Application for Works Approval

Works Approval Number W6623/2021/1

Applicant Pilbara Iron Company (Services) Pty Ltd

Premises Paraburdoo Iron Ore Mine and Eastern Range Project
ROCKLEA WA 6751

Figure 1: Distance to sensitive receptors

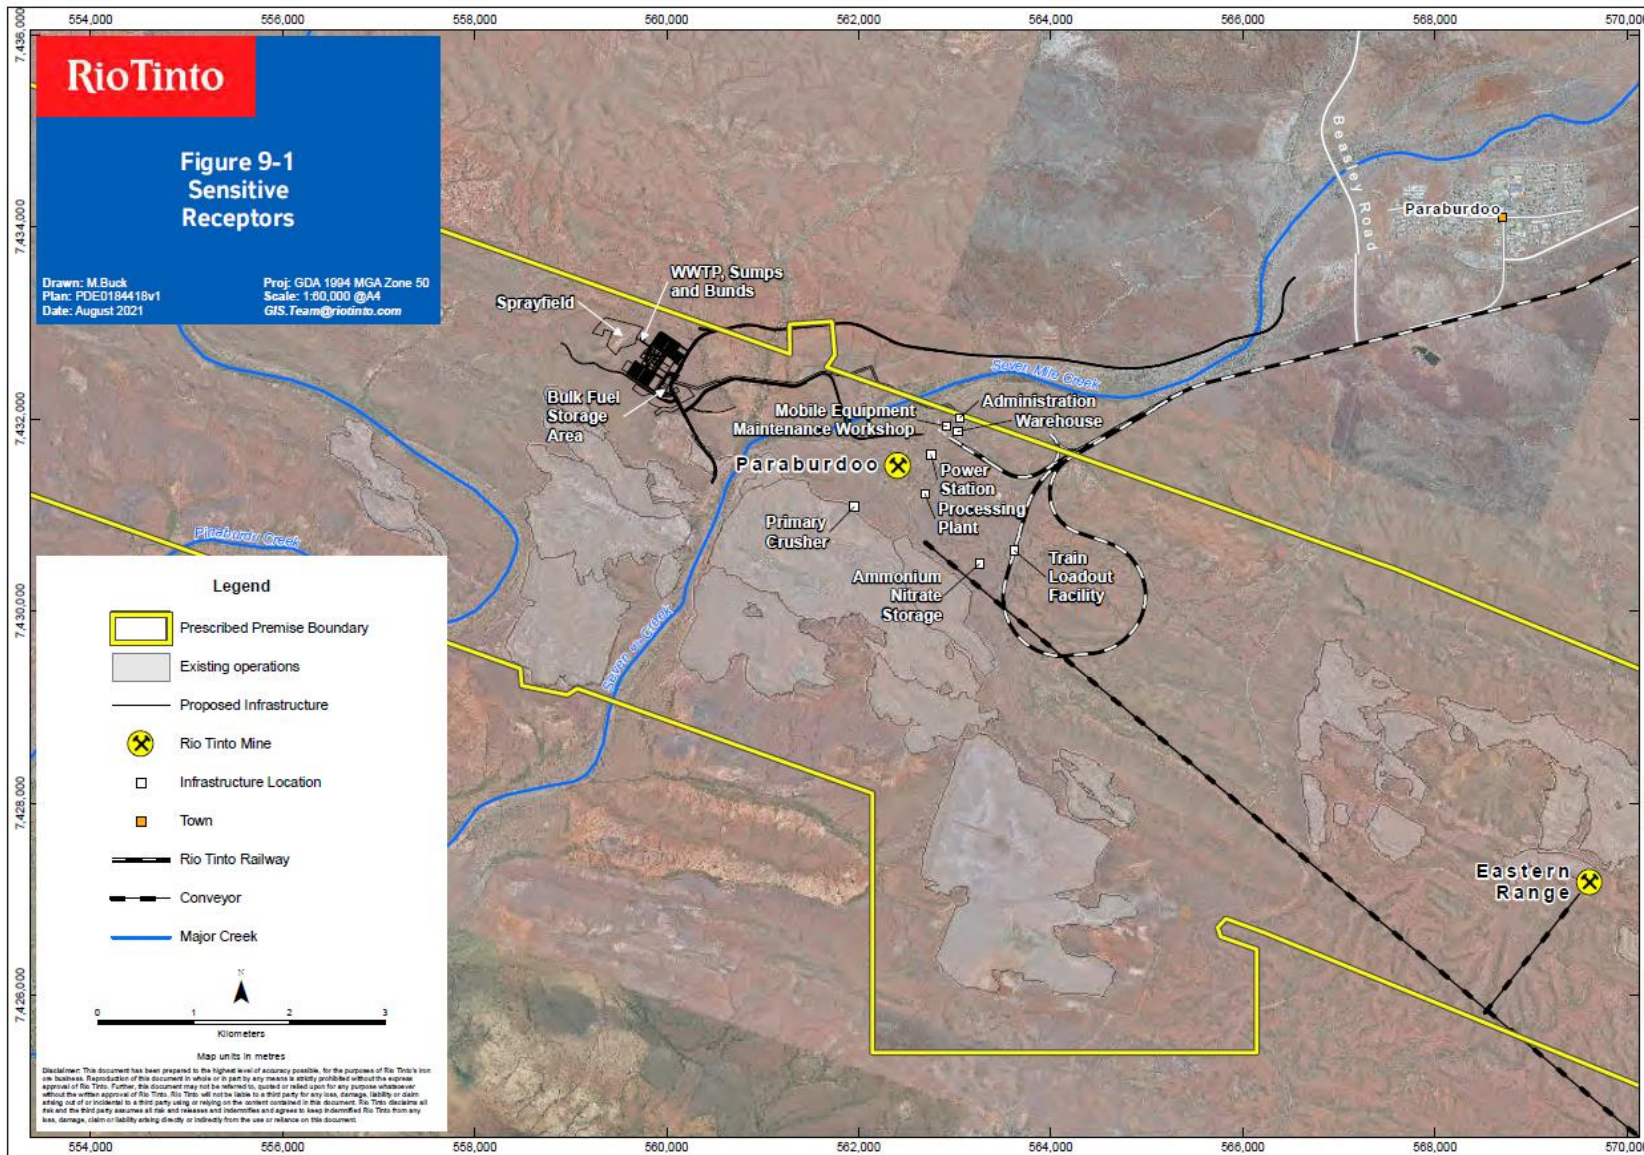
Condition of Works Approval	Summary of applicant's comment	Department's response
23	Update condition numbers.	Updated to reflect final condition numbering.
Schedule 1: Maps Premises Map	Request (<i>Error! Reference source not found.</i>) is updated to Figure 1.	Updated to remove the error and replace with Figure 1.
Schedule 1: Maps Sprayfield Map	Map of the boundary of the sprayfield is incorrect. Request updating map match the sprayfield boundary in Figure 1.	Figure removed.
